USNRC APPLICATION
Combined Source and 11e.(2)
Byproduct Material License

*The Reno Creek ISR Project
Campbell County, Wyoming*

**Responses to
Open/Confirmatory Items**

April 2015

C-3.4

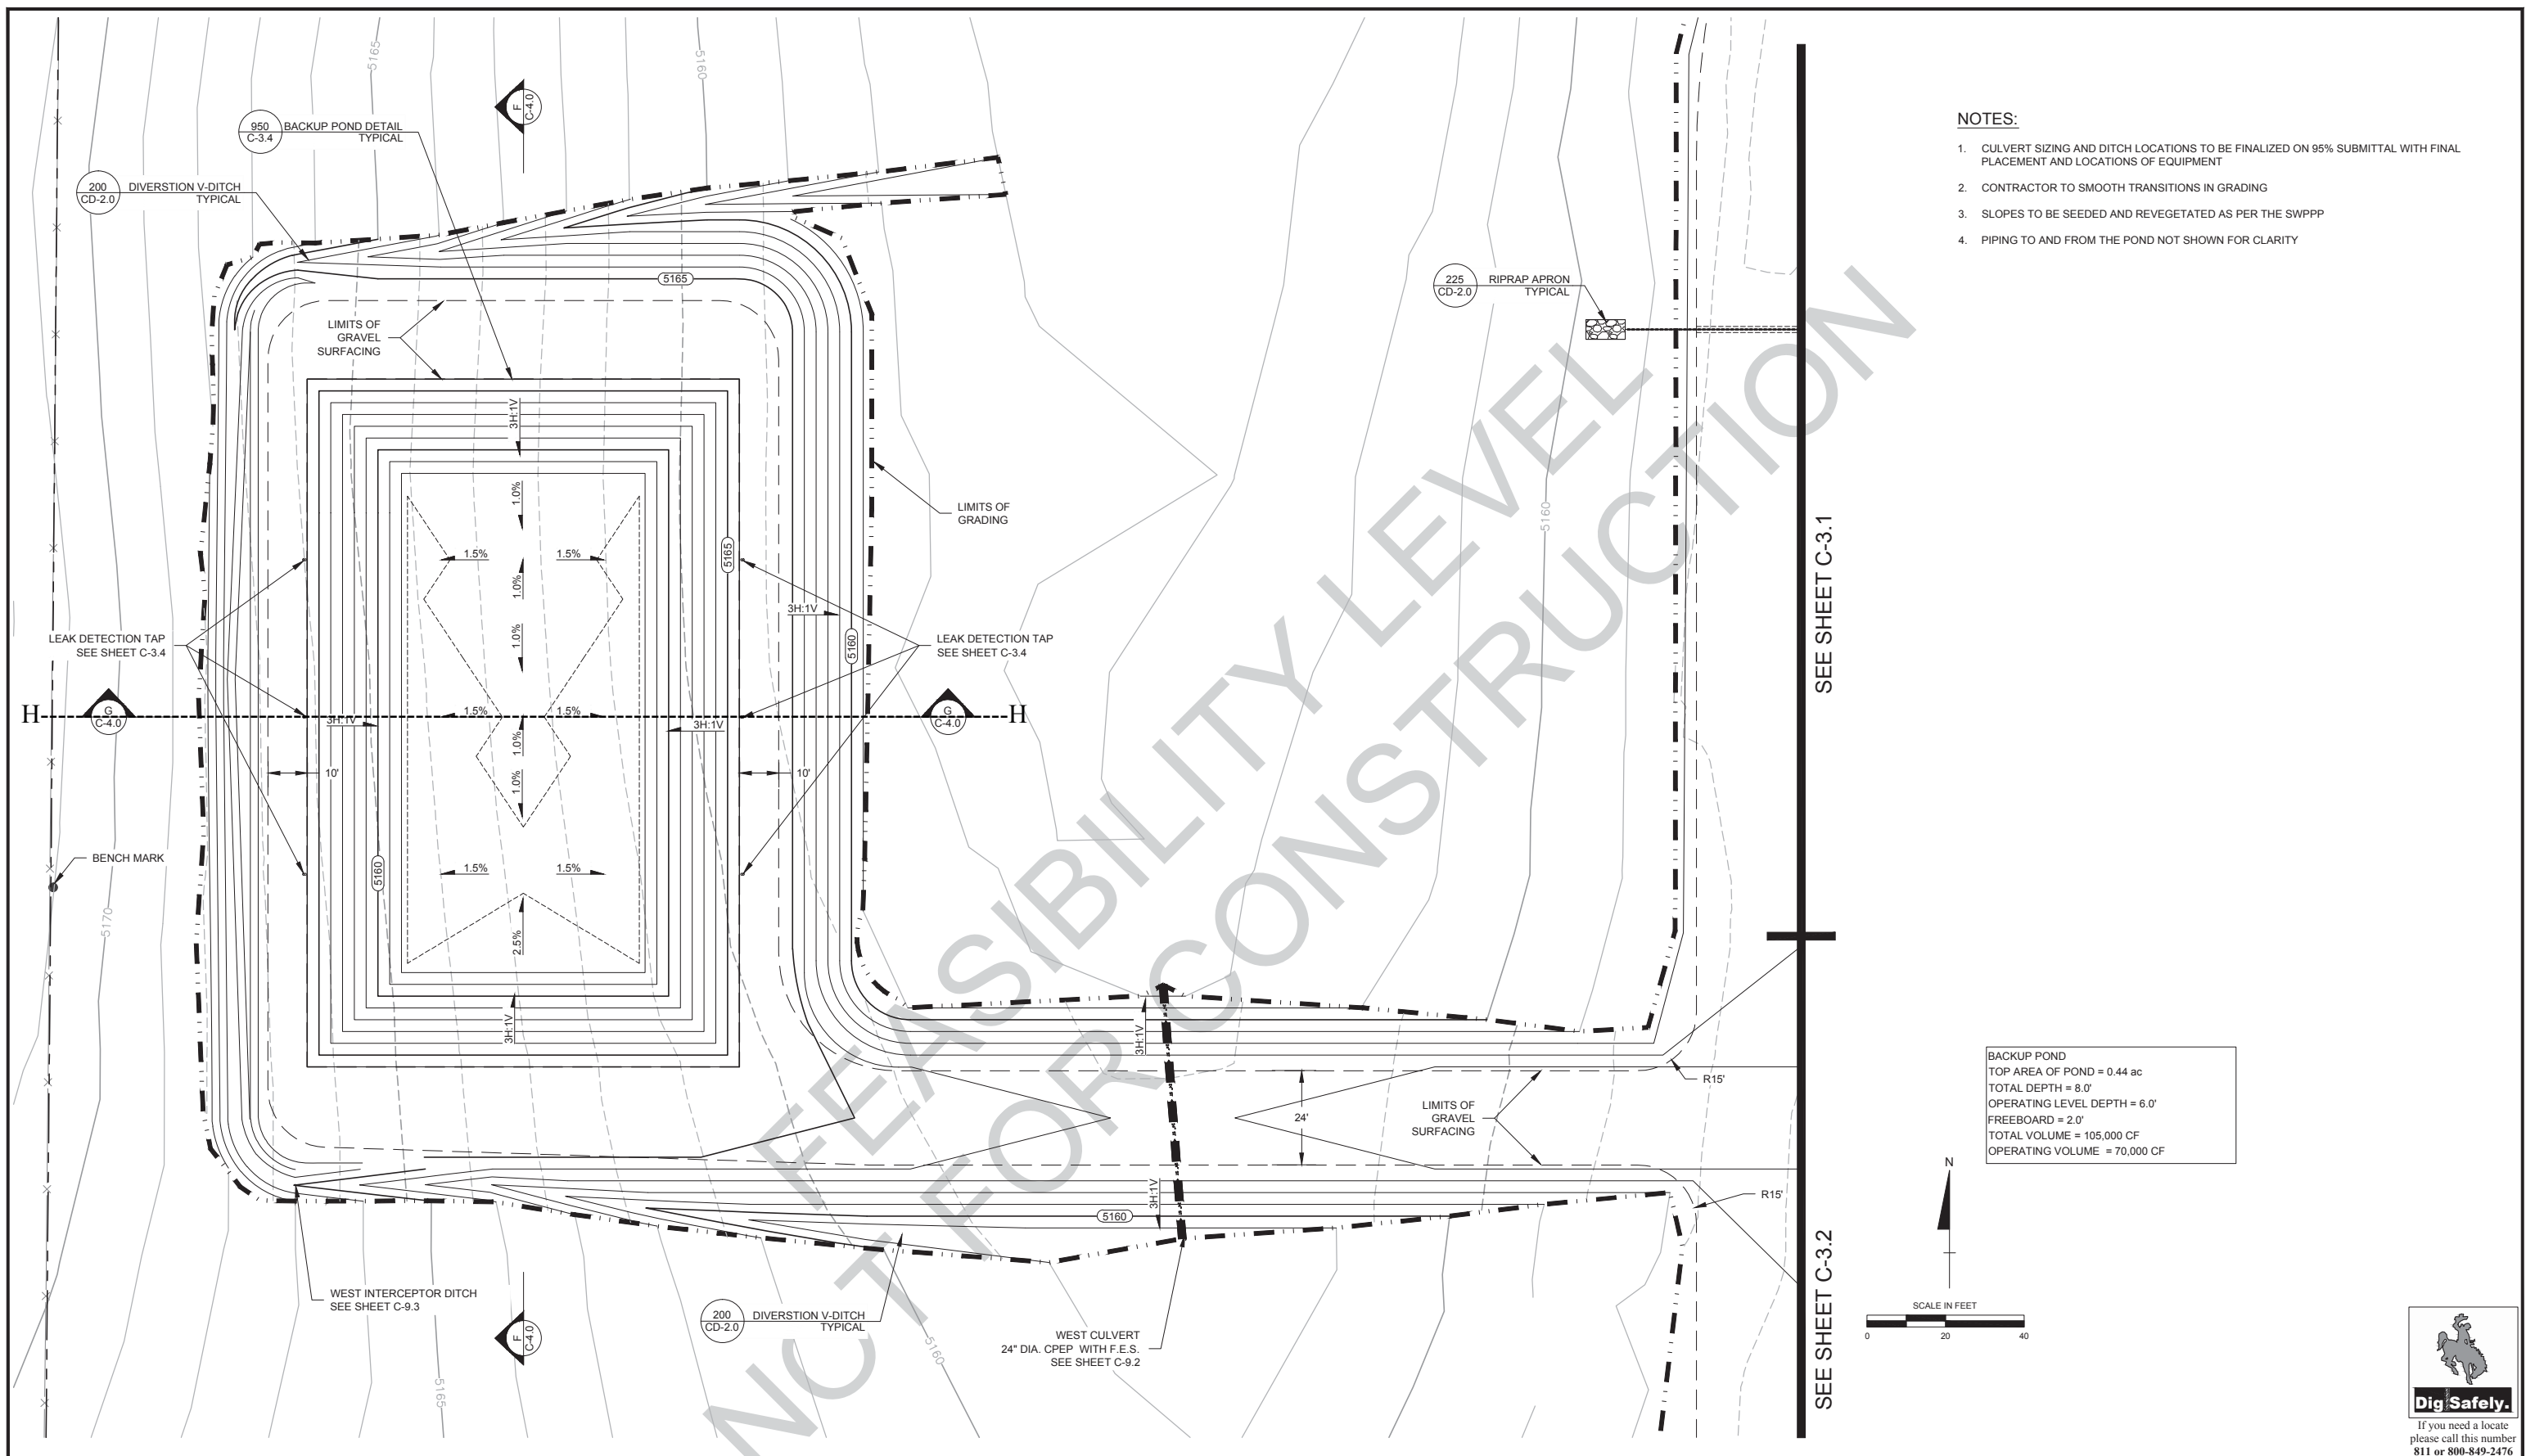
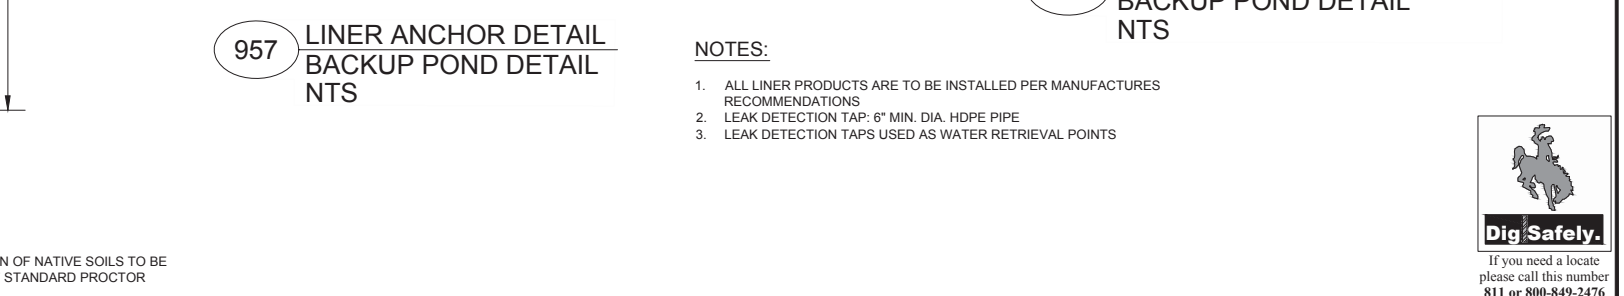
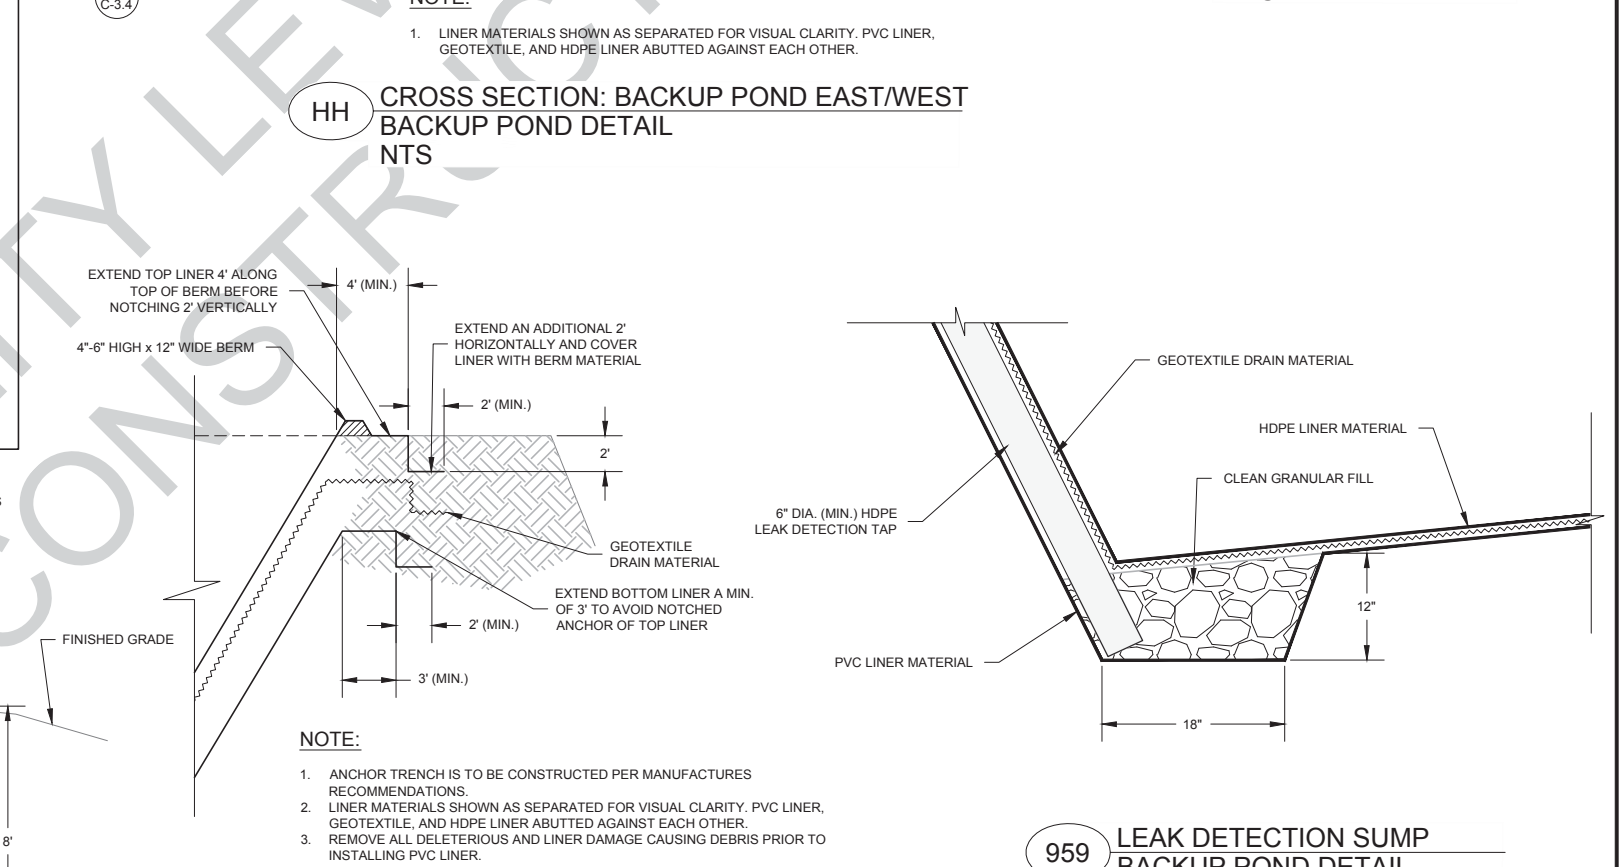
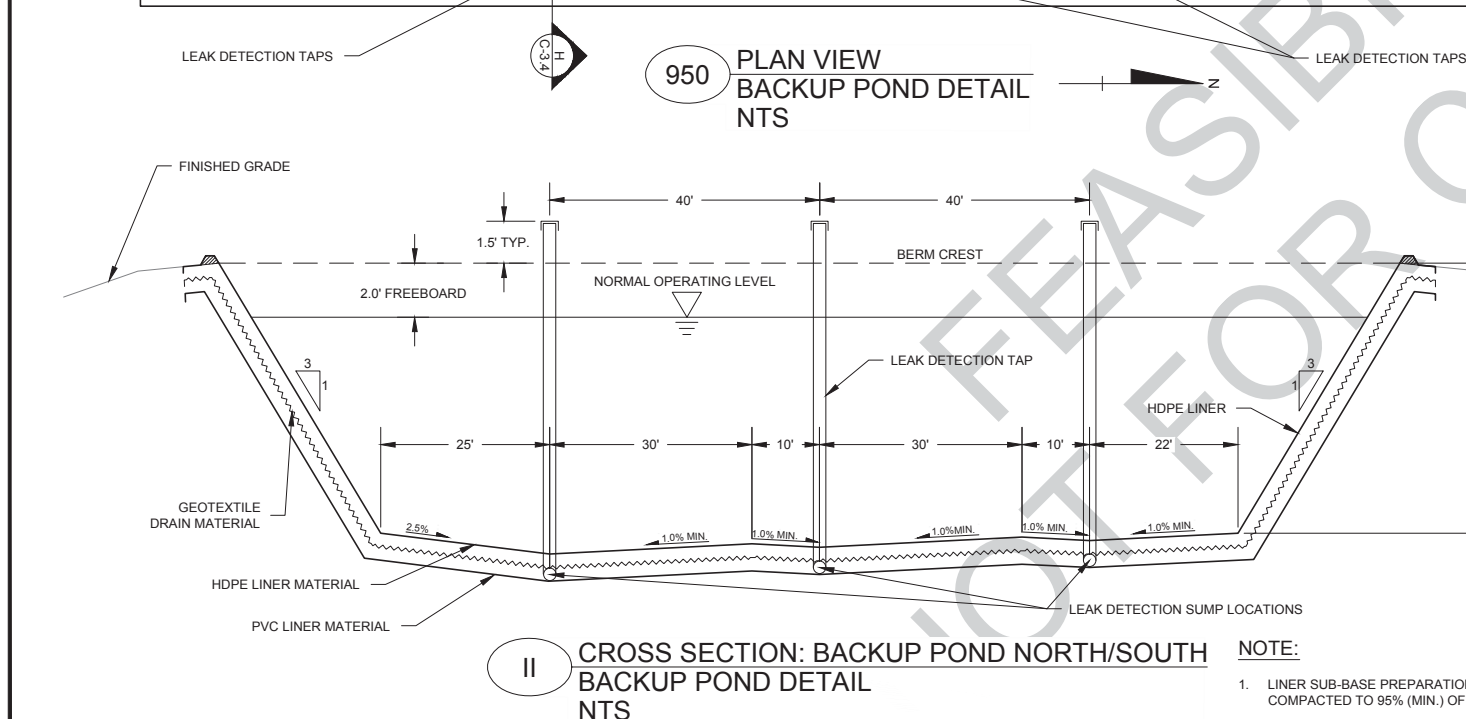
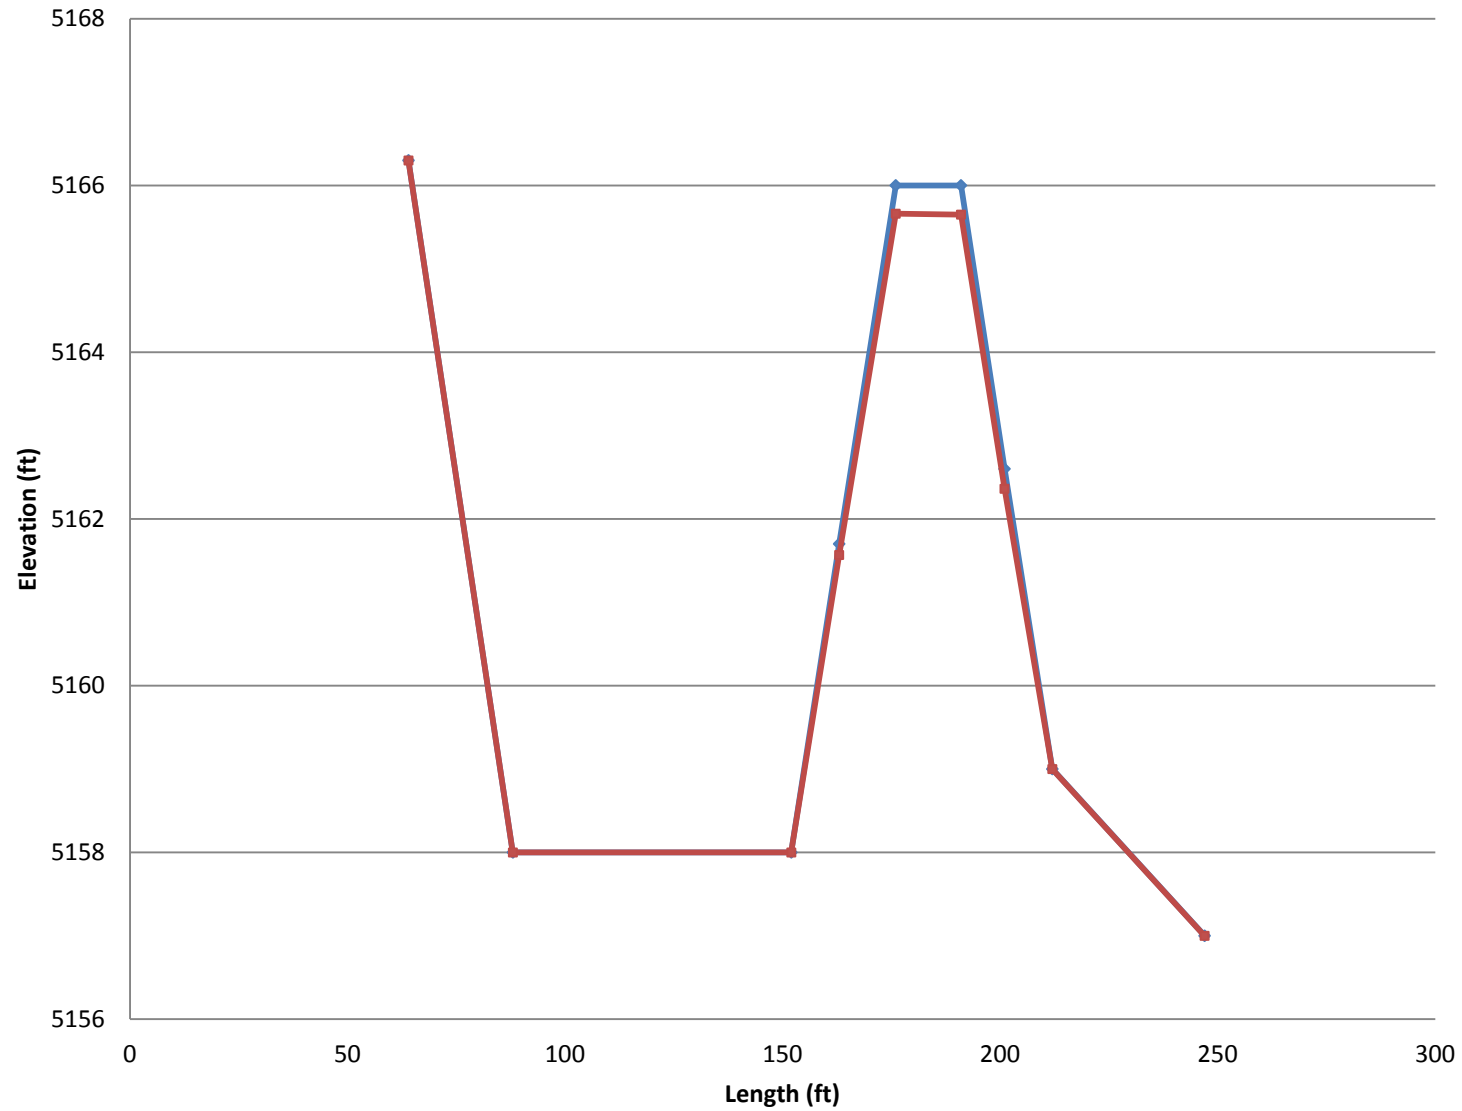
In its response to RAI 39, AUC stated that the liner system design was contained in Technical Report section 4.3.5.1. NRC staff reviewed the information in the technical report and understands that AUC intends for the liner to consist of the following components (listed from top to bottom):

In its response to RAI 39, AUC stated that construction specifications were located on drawings C-3.3 and C-3.4 of Addendum 3-A. The NRC staff also reviewed the response to RAI 32, which did contain some information on specifications for the drainage layer. The NRC staff was able to locate some specifications, such as the 95 percent compaction requirement for the subgrade below the liner and the transmissivity of the drainage material. However, the NRC staff has not been able to identify the minimum strength requirements for geosynthetics planned for use in the liner system. Note that 10 CFR part 40, Appendix A, Criterion 5A(2), 5A(4), and 5A(5) applies to both design and construction of surface impoundments. AUC can resolve this open issue by identifying engineering properties for items used in construction of the storage pond liner system.

Sheet C-3.4, Grading: Backup Pond Details of the civil engineering package titled “Civil_Site-20121002” located in TR Addendum 3-A (reference RAI 39) has been revised to reflect AUC’s commitment to use a geosynthetic liner with the material and thicknesses identified above. The proposed thickness of the liners has been added to the engineering drawing.
